USM-EXHCV-26/08
FORD CARGO
PRODUCT IMPROVEMENTS
&
SERVICE ACTIONS AND
RECOMMENDATIONS

Updated
31/08/2008

TAG AXLE LIFTING PISTON FAILURES

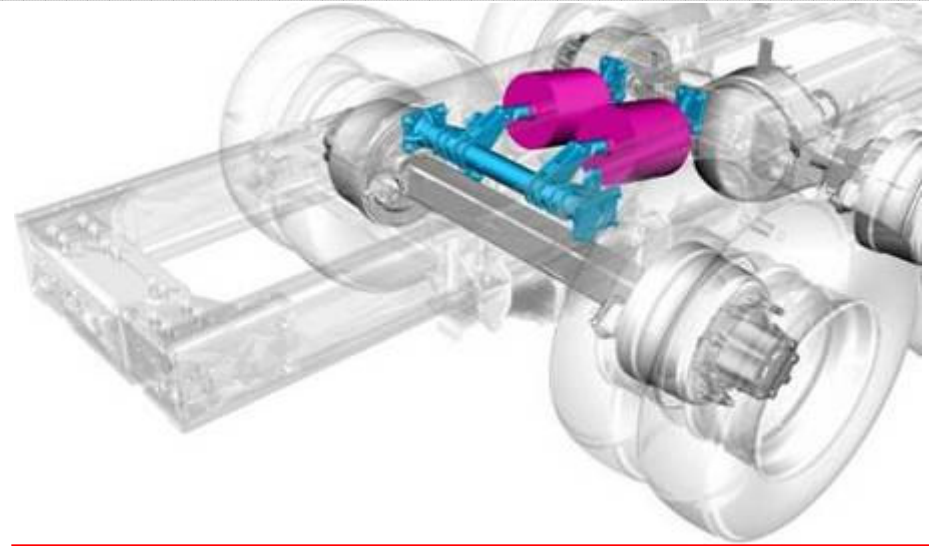
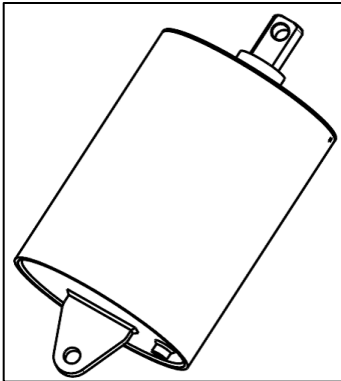
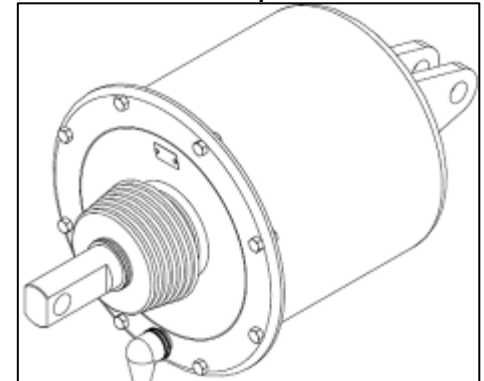
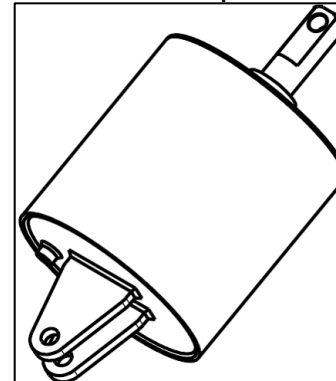
Problem : Supplier quality problems.

Root Cause : Part has been manufactured by two different suppliers.

Action : Problem part and manufacturer has been removed from production.

Impl. Date: **September 2007**

Starting with the vin : **64923**

OIL LEAKS ON WHEEL HUB SEALS

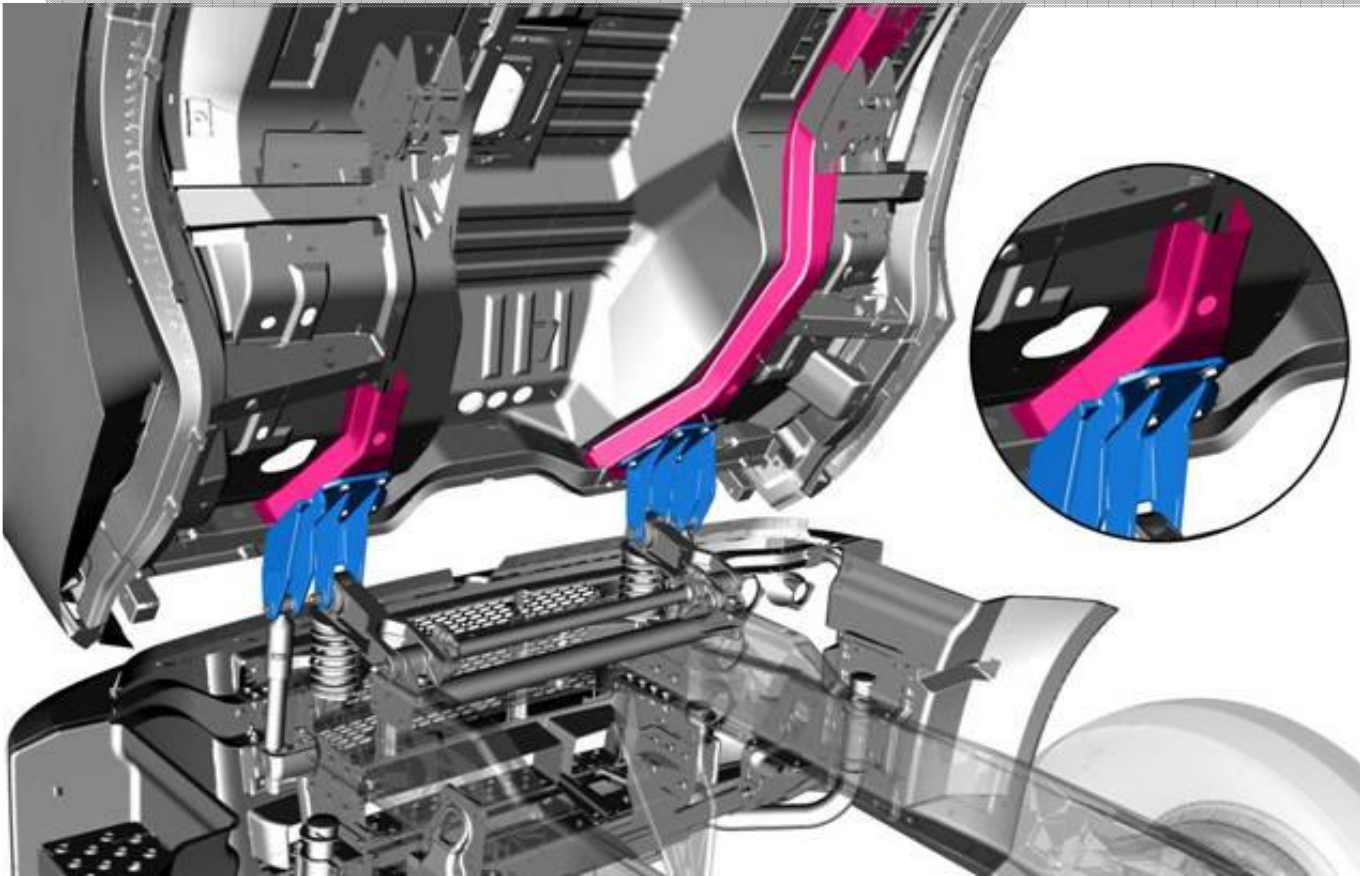
Problem : Oil leaks on wheel hubs

Root Cause : Quality problems

Action : Viton brand oil seals, that are resistant to heat and differential oil, have been released except front wheels.

Starting with the vin: 69658 Implementation date: **April 08**

BREAKAGE OF CROSS BRACKET UNDER CAP

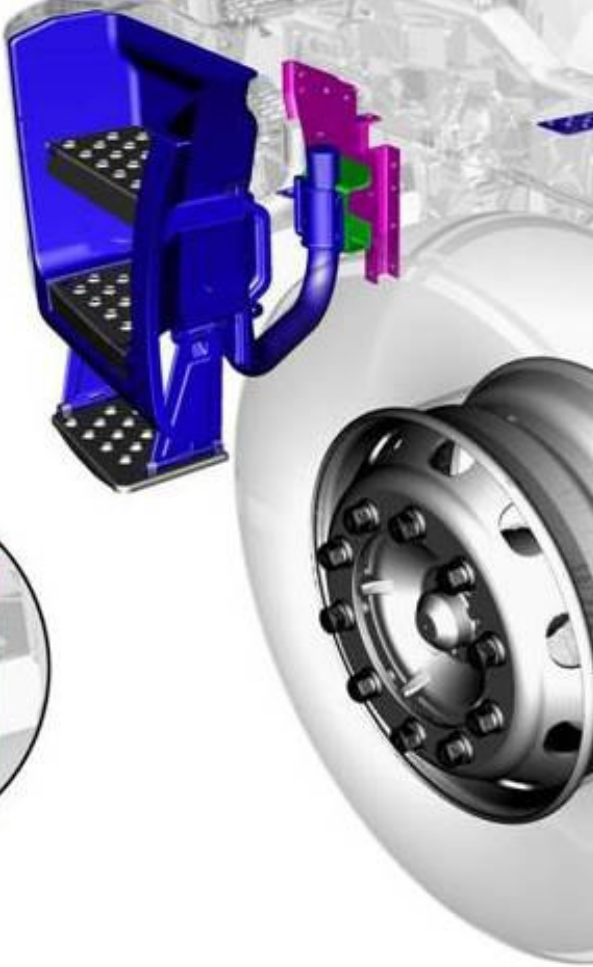
Problem : Cross bracket breakage under the cabin

Action : Internal areas of cab cross bracket reinforced and durability 500% improved.

Impl. Date: **October 2007**

External reinforcement bracket released for after sales :

7C46-E00284-AA / BA

DOOR LOCK FAILURES

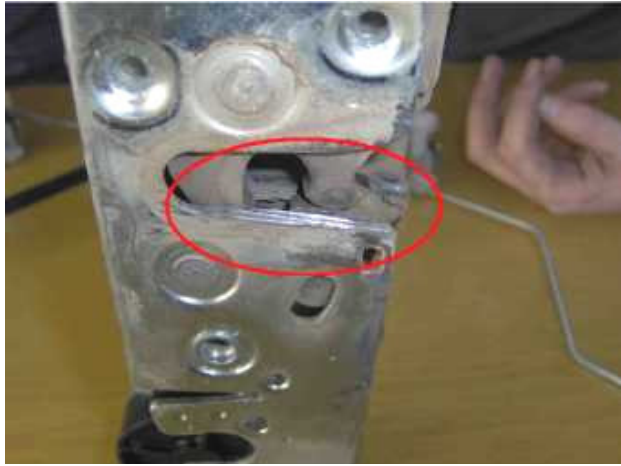
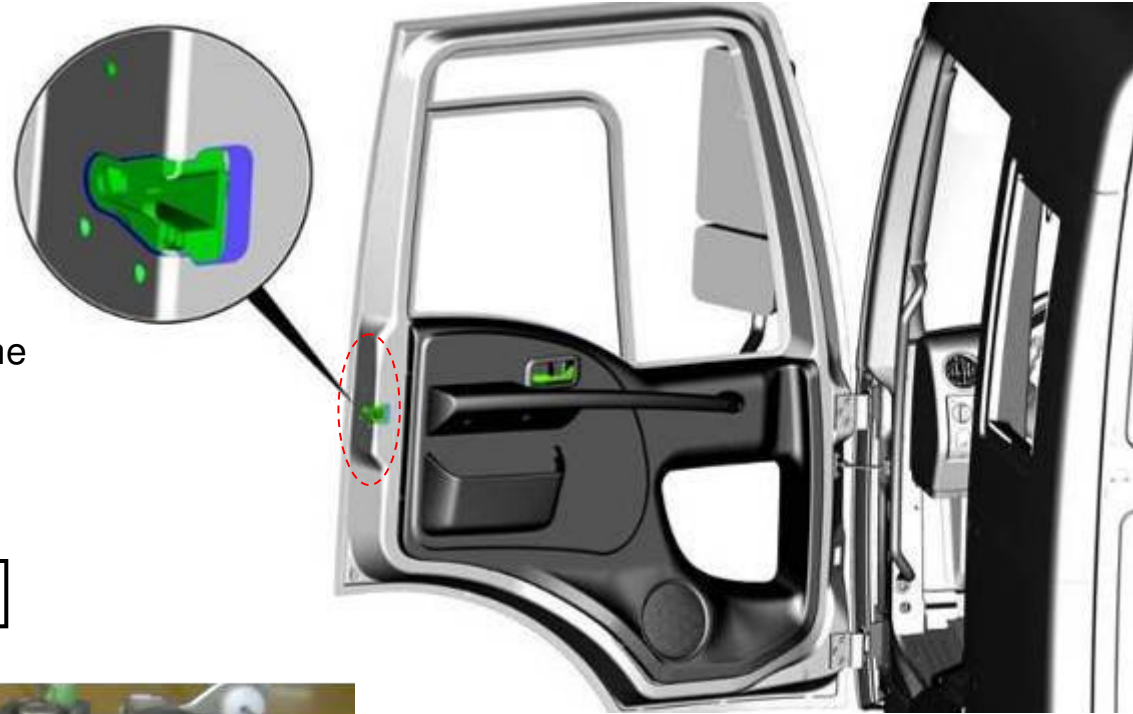
Problem : Malfunction of door locking mechanism

After locking, one or both doors can be unlocked by remote control.

Action : Revisions applied to minimize the gaps on latch location.

Inner door handle bezel has been revised to decrease the operation efforts.

BREAKAGE OF REAR FENDER(CAP) AND ITS BRACKET

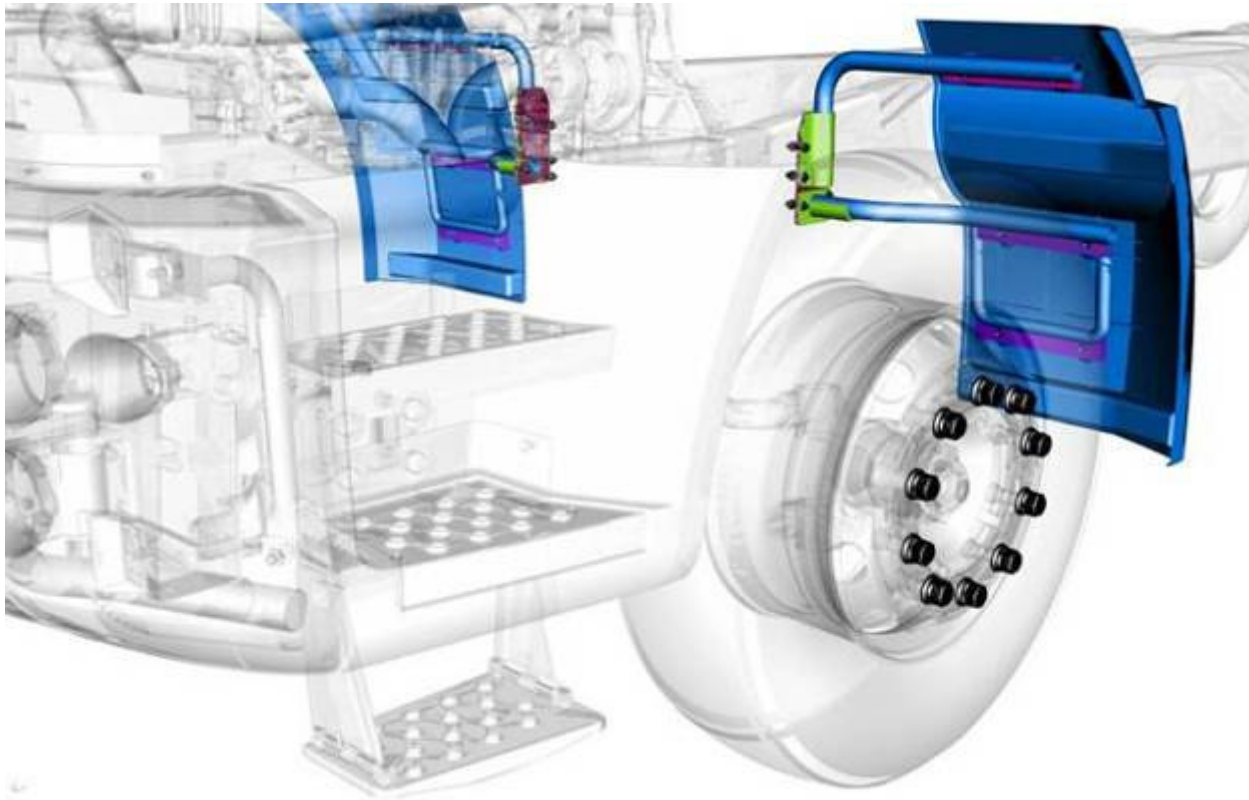
Problem : Breakage and cracking problem of rear fender and its bracket because of excessive vibration.

Action : 1) Rubber added to fender material and flexibility and endurance of the part increased breaking and cracking problem from attachment points eliminated.

2) Reinforcements added behind the body attachment brackets and welding process optimized.

3C46-16K039/40-BC

DUST INGRESS INTO CABIN

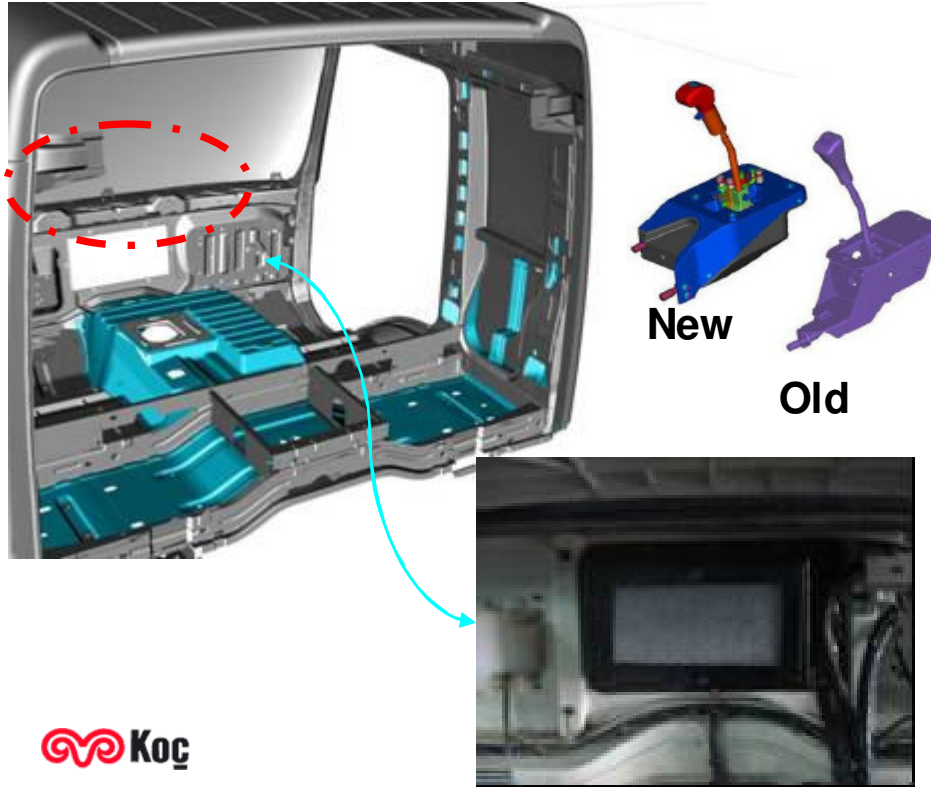
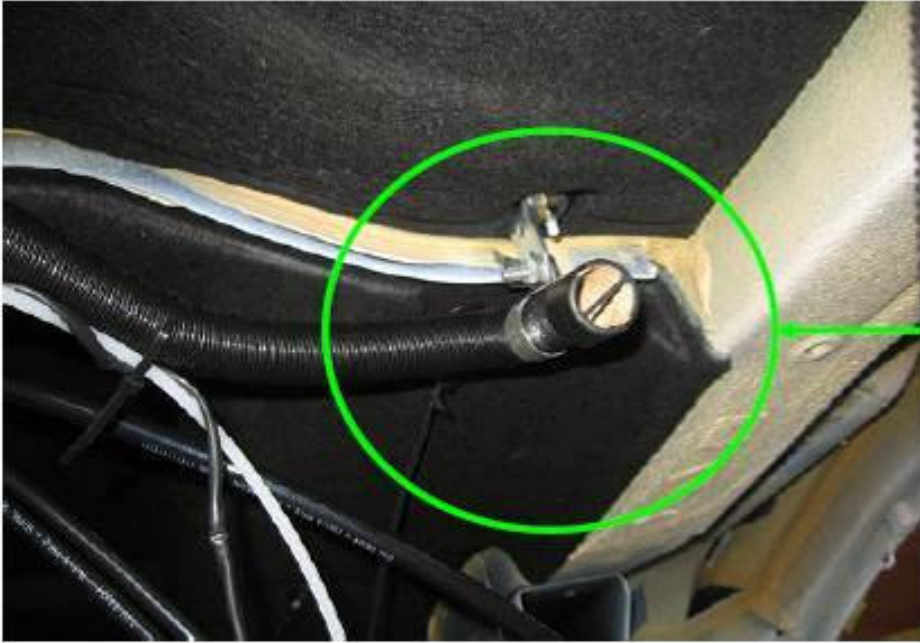
Problem: Dust ingress into driver's cabin

Actions : Pad installation on WEBASTO discharge point of damp trucks
Impl. Date: **May 2007** Vin no: **63330**

Gearshift area insulation provided by new gearshift lever.
Imp. Date: **December 2007** Vin no: **67586**

In order to prevent the dust ingress from the shifting mechanism, gear lever gaiter improved for the vehicles manufactured before the vin **67586**

Holes on the cabin are closed by suitable plugs.

INSIDE CABIN HEATER – EBERSPACHER PROBLEM

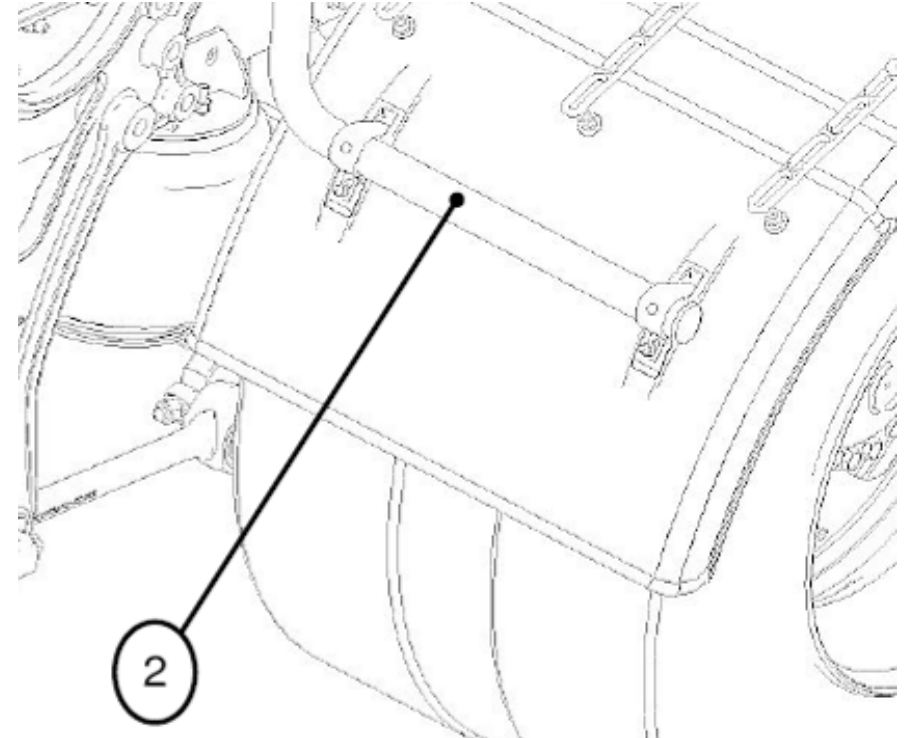
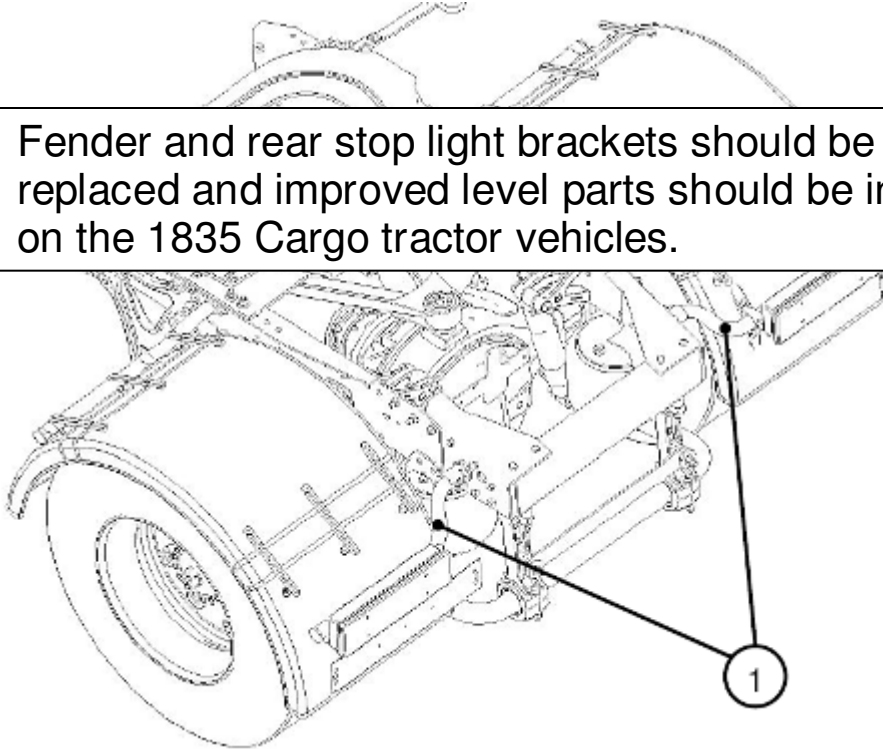
Problem : Dust ingress into Eberspacher Cabin Heater motor on 7,3lt Cargo 240&300 PS vehicles

Root Cause: Incorrect part installation

Action : Clean air intake pipe of the heater, re-assembled to opposite position to driving direction to eliminate the problem

Clean air intake pipe routed opposite to the driving direction.
